**TO:** Planning Commission  
**FROM:** Ben Prchal, City Planner  
**AGENDA ITEM:** The Legacy at North Star Fourth Addition – Final Plat and PUD Plans  
**REVIEWED BY:** Ken Roberts, Planning Director

### FINAL PLAT/PLANS: LEGACY AT NORTHSTAR 4TH ADDITION

# LEGACY AT NORTH STAR 4TH ADDITION

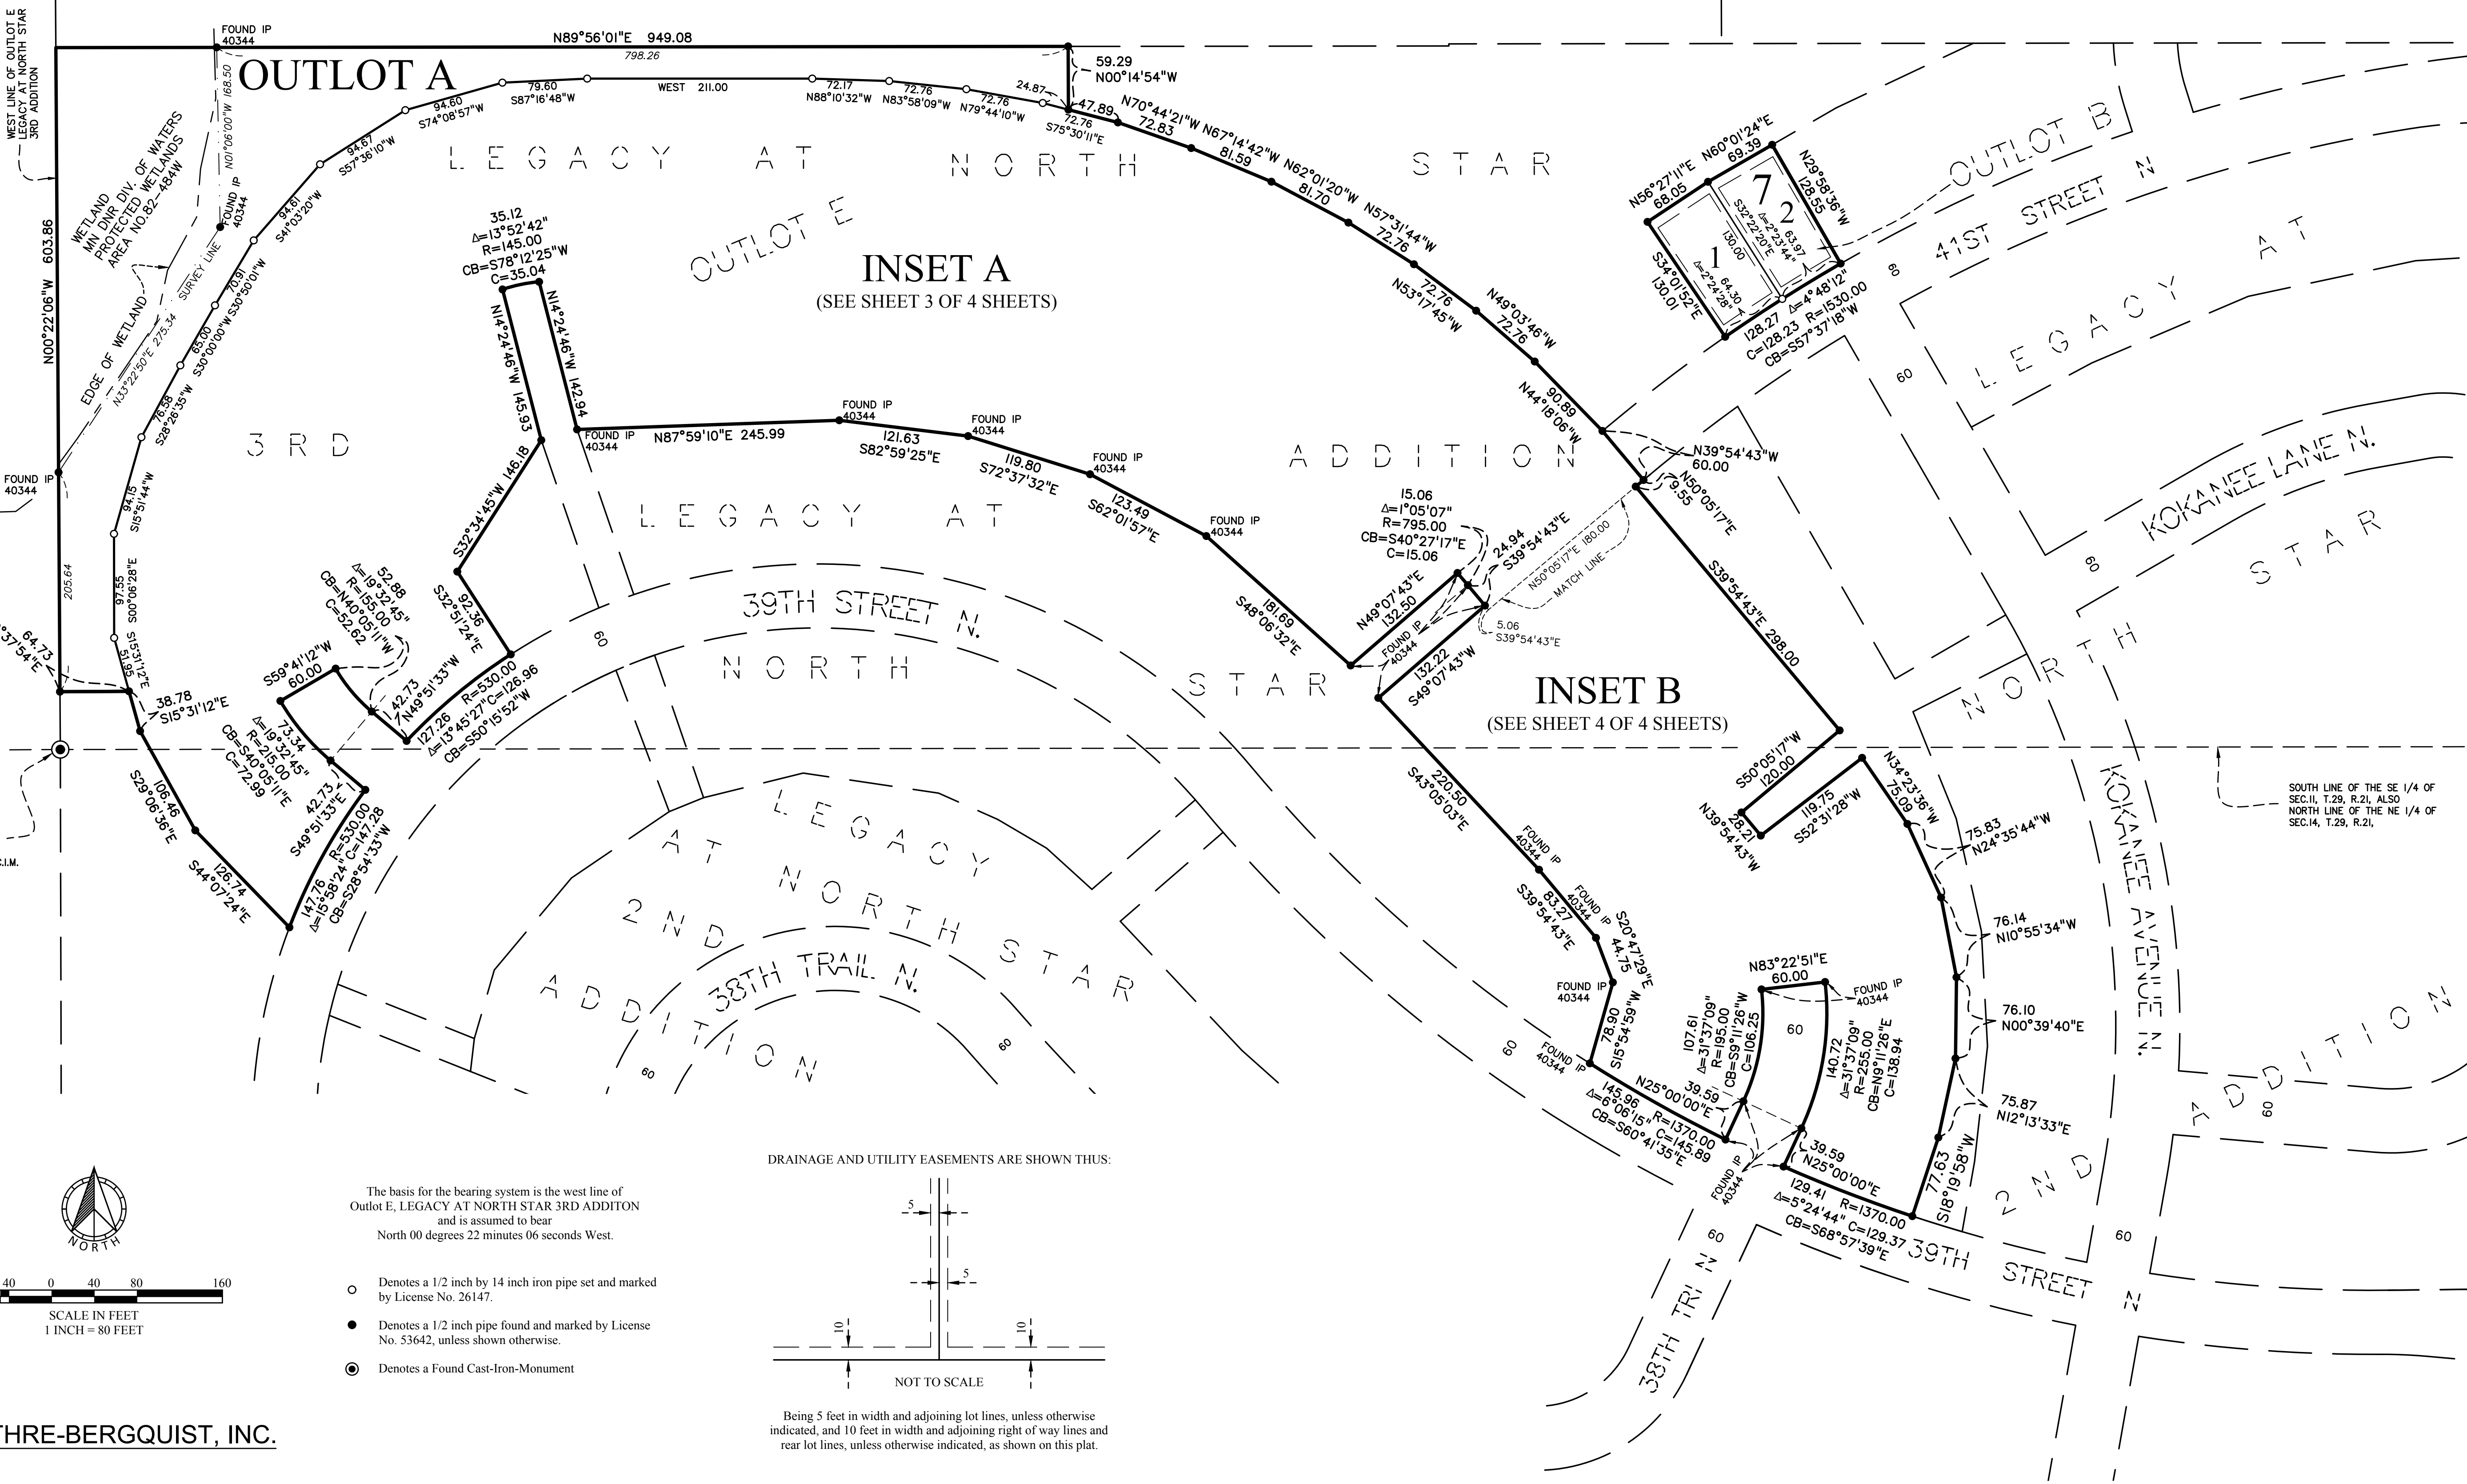
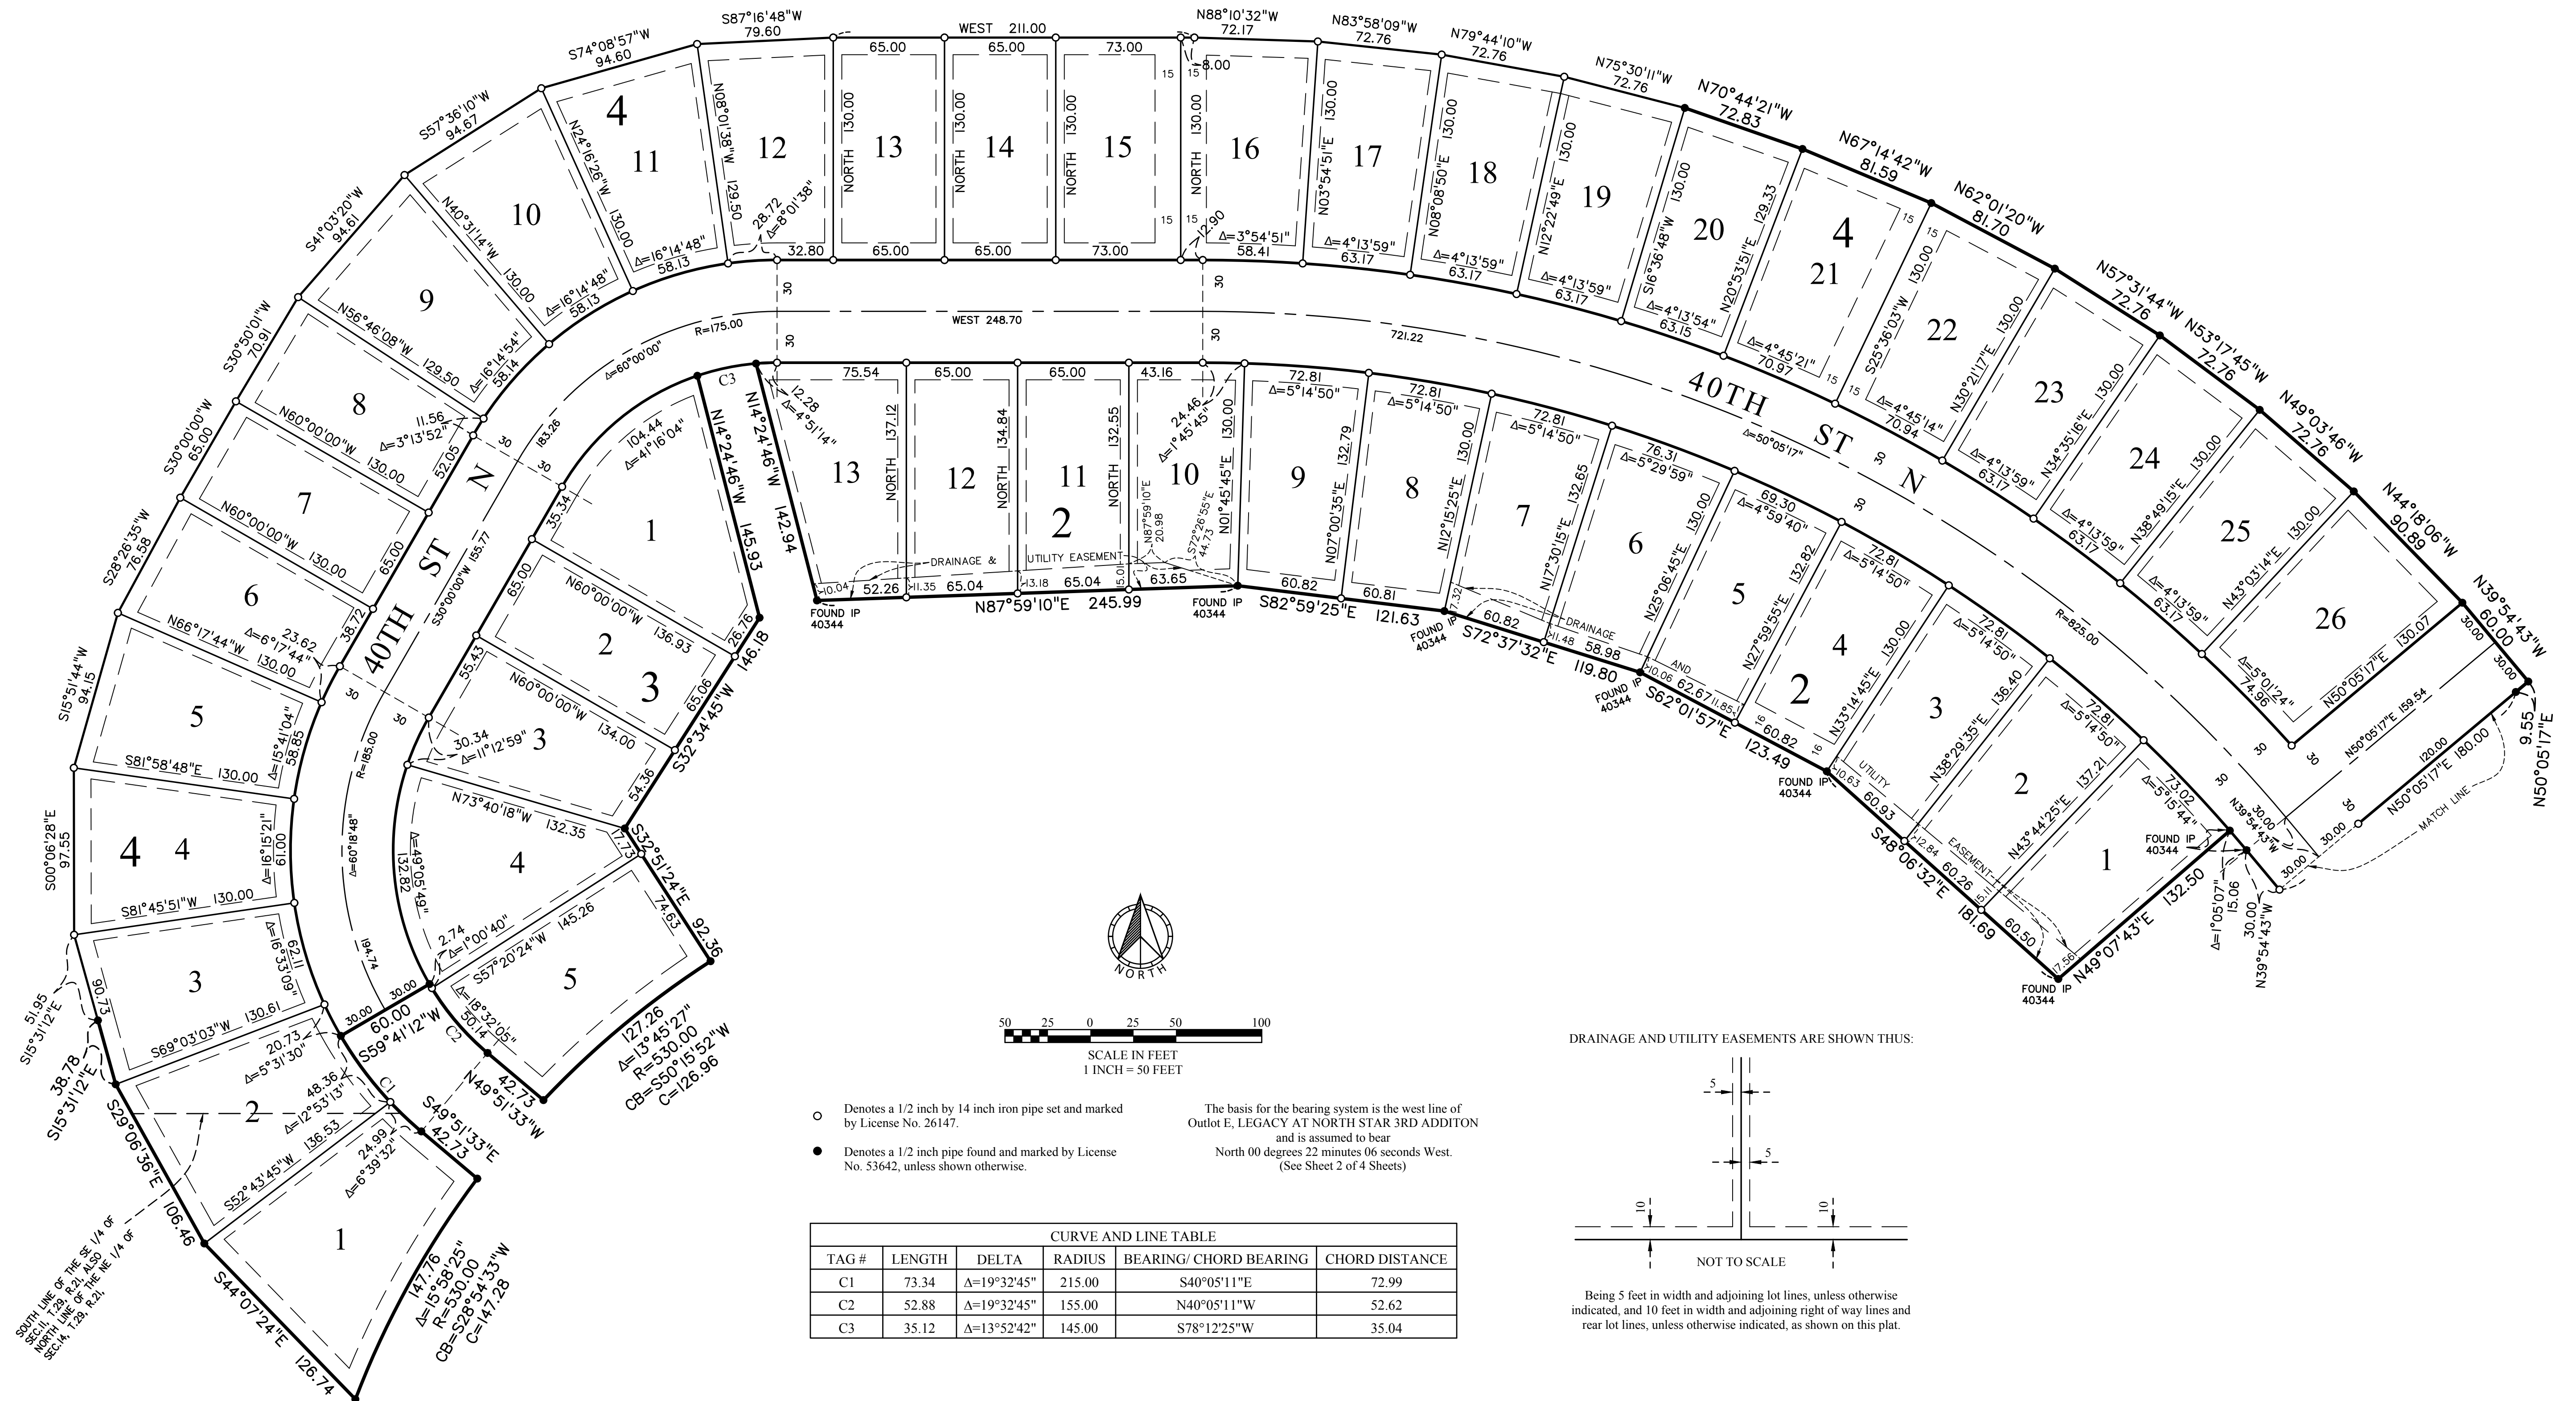
- Outlot A is shown as City owned on the Plans. This must be revised on the Plans to be HOA owned with a drainage and utility easement over all of Outlot A.

- All easements as requested by the City Engineer and Public Works department shall be documented on the Final Plat prior to the release of the Final Plat for recording. The Final Plat must be revised to show a drainage and utility easement over all of Outlot A.

- The rear yard lot easement must be revised on the Plat and Plans for Lot 10, Block 2. The easement should be a straight line while containing the localized HWL within the easement area.
